INSTALLATION MANUAL

REF NO.	BT96040
DATE	Jul. 4, 1996

SUBJECT: CHANGE IN TORQFLOW ASS'Y FOLLOWING SNAP RING CLEARANCE CHANGE ON WA800

PURPOSE: To introduce improved parts to prevent dropping off of the turbine bearing of the torque converter of WA800-1 and WA800-2 wheel loaders.

2. Contents of the modification

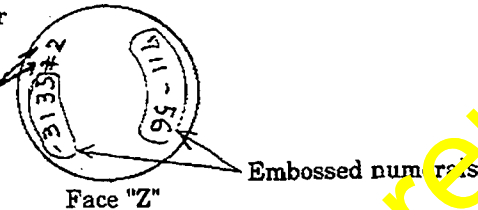
When the speed is shifted down beyond the speed range of each speed stage, the revolution of the outer ring of the turbine bearing (means the engine revolution) rises and the snap ring of the turbine bearing may drop off due to centrifugal force. (For example when the speed is shifted down from F3 → F1 skipping a stage)

To prevent occurrences of such accidents, the shape of the input shaft (02) and casing (03) according to (04) and (05) to reduce the clearance in the outer peripheral direction and in the axial direction, thus preventing dropping off of the snap ring even under high speed revolutions.

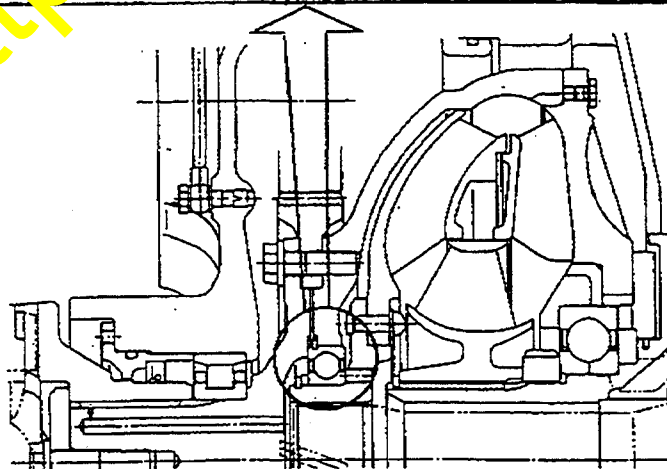
- Identification method of the new and current input shafts (between (02) and (04))
The new part number (711-56-31353) is marked on the face "Z" according to the schematic diagrams below by combination of embossing and stamping.
- Identification method of the new and current casings (between (03) and (05))
An identifying groove is provided at the section "P" according to the drawing below (with the (05) part only)

A portion of the embossed current part number is ground off using a grinder and correction numerals are stamped to constitute the new part number.

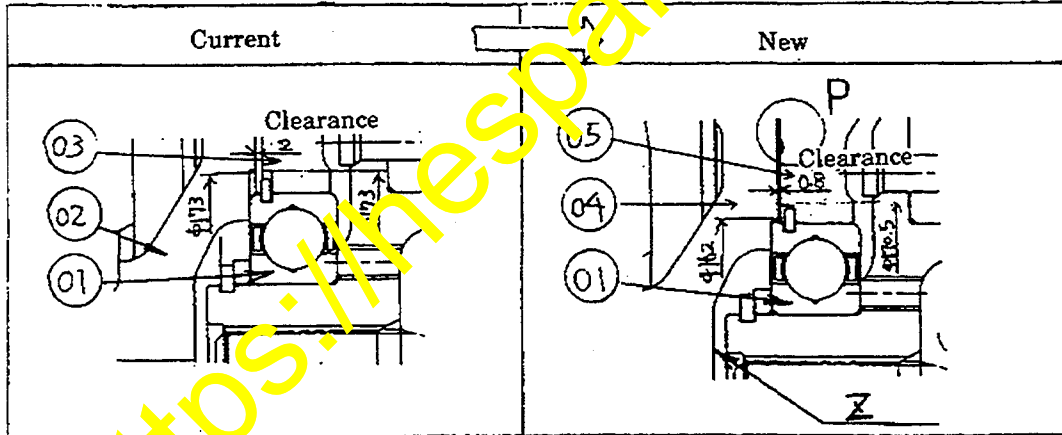
The identifying groove being provided at the section "P".
